3. Chimney Repairs - (Revised Update)

Cathedral Courts Conservation Plan Amendment 1

2018-08-22

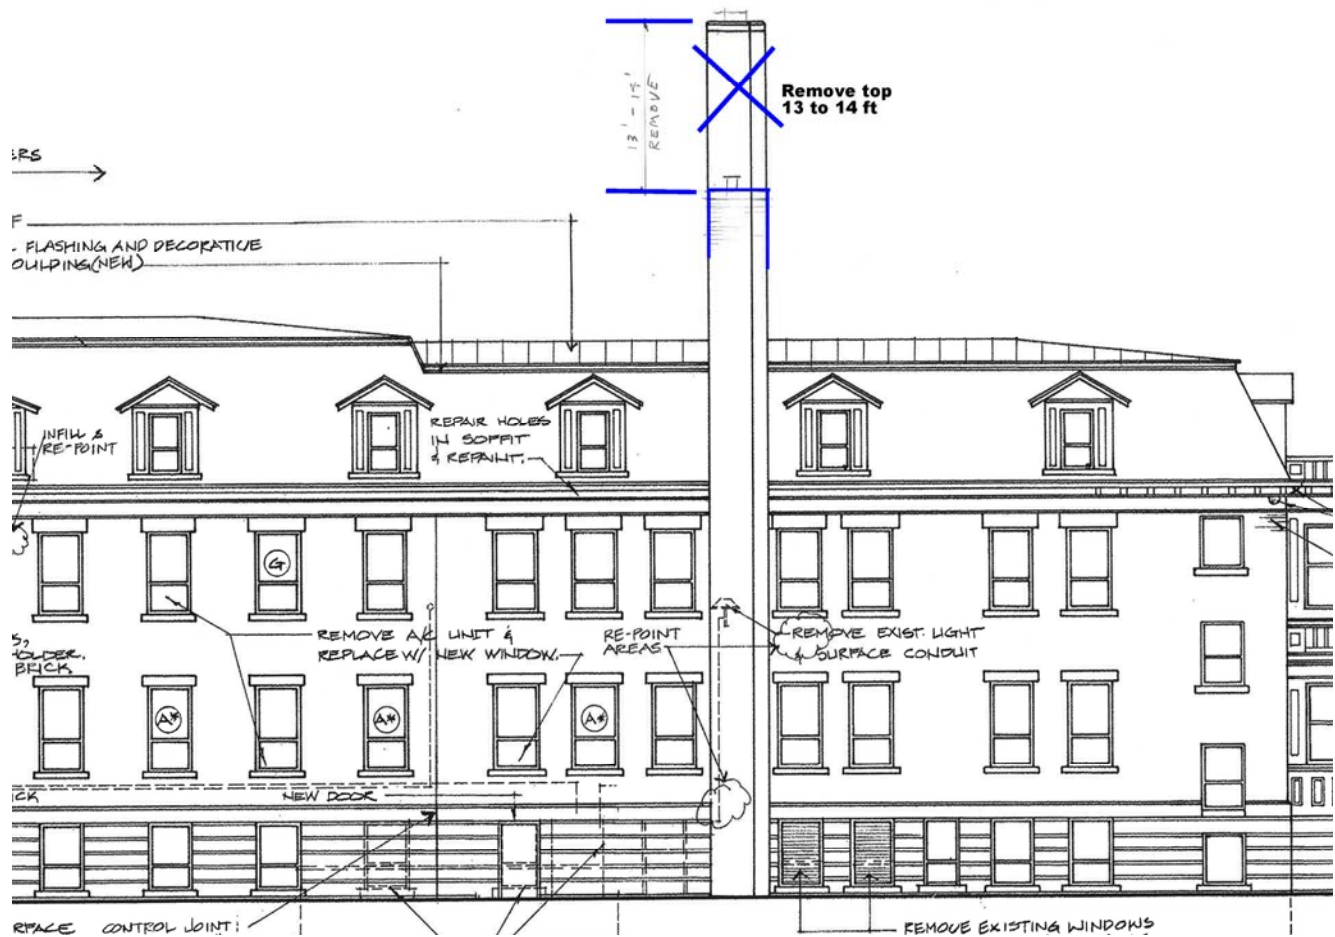
Assuming the new chimney does not have to be as high as the existing, from a structural perspective, it would be beneficial to remove the upper portion of the brickwork no longer required. The deterioration is most pronounced in the upper sections. There would be less wind exposure area, and thus less vertical and lateral loading on the brick chimney construction. There would be less area required to replace / repoint / reinforce.

Attached are a few conceptual sketches for consideration. There were several assumptions noted in developing the sketches. Materials and finish of materials will need to be reviewed. Stainless steel offers the most protection to the elements. Galvanized or epoxy coated would be next, but all damaged surfaces need to be repaired or the corrosion concentrates at the point of the imperfection. Rusting surfaces will stain the brick. It may be preferable to match the color / finish / profile to be as least visible as possible.

The reinforcing could be installed in pair, staggered vertically and rotated. It would be prudent to tie the chimney back to the roof.
